**ADDENDUM NUMBER 1**

Issued: July 7, 2011

**KAWANA SPRINGS WATER STORAGE TANKS FENCE REPLACEMENT PROJECT**

**FENCING PLAN**  
SCALE 1" = 30'

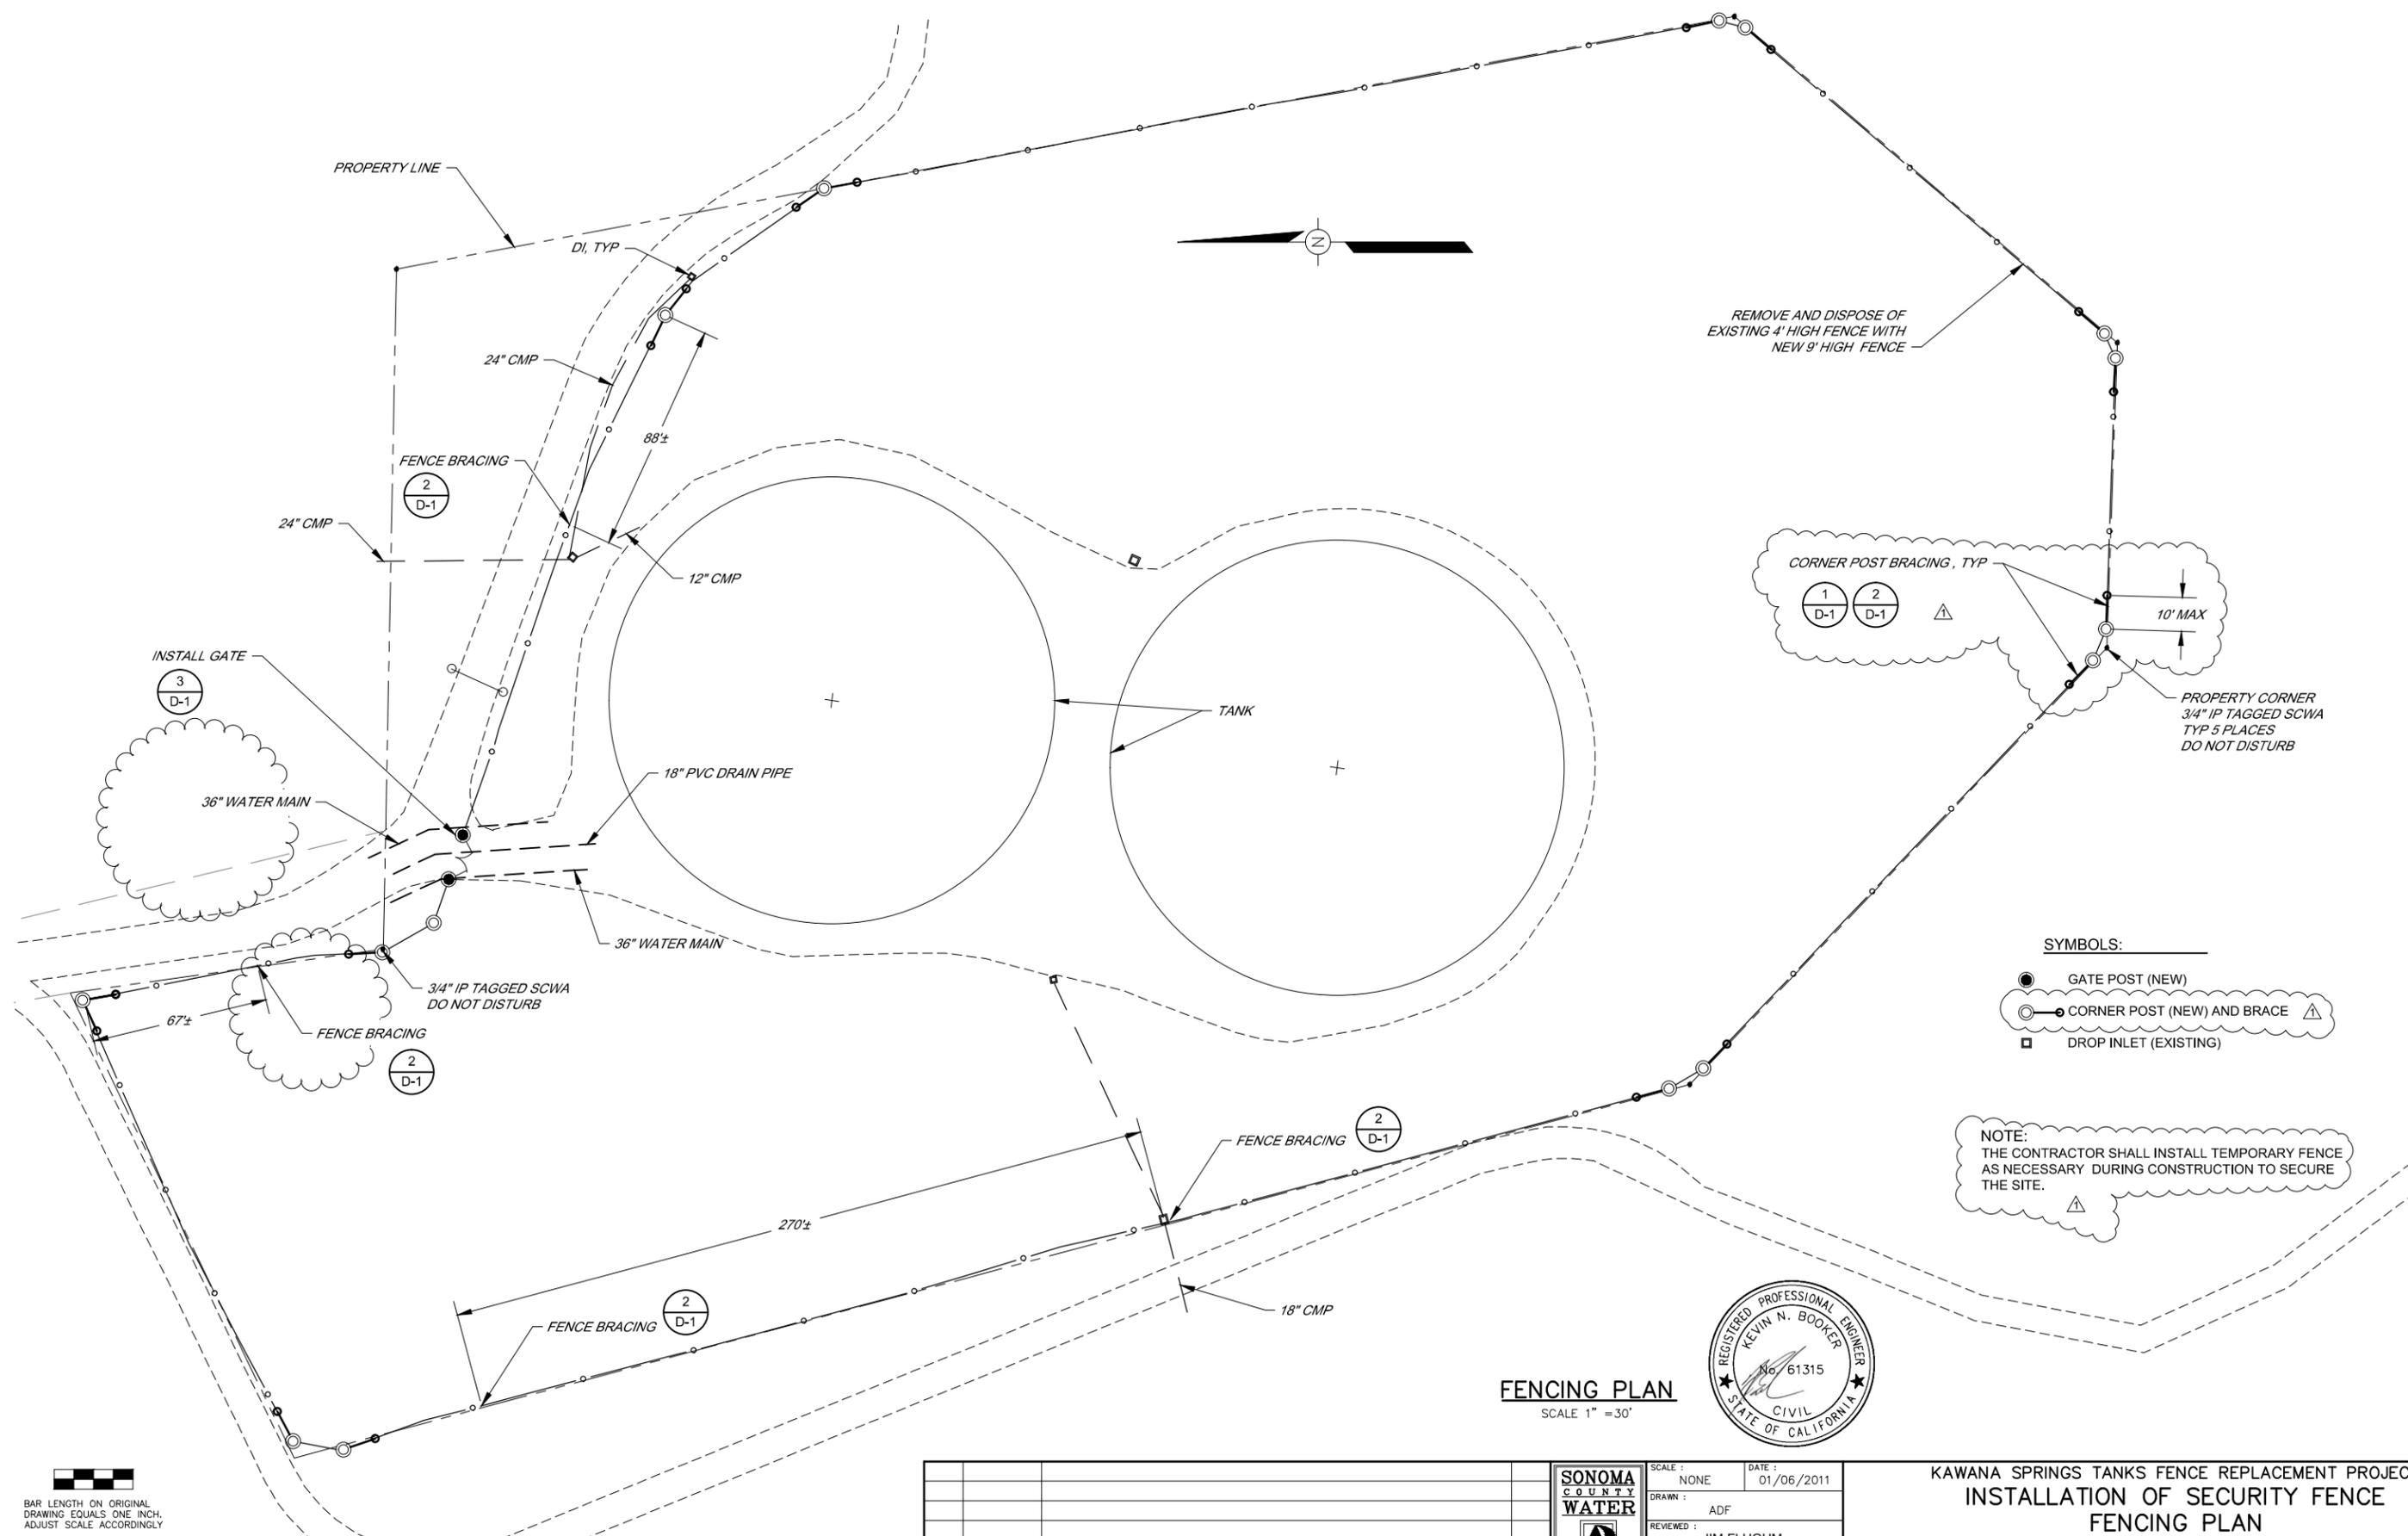
- A. Delete Drawing C-1 and replace with attached Drawing C-1, marked "06-22-2011 ADDENDUM No. 1."
  - B. Delete Drawing D-1 and replace with attached Drawing D-1, marked "06-22-2011 ADDENDUM No. 1."
-
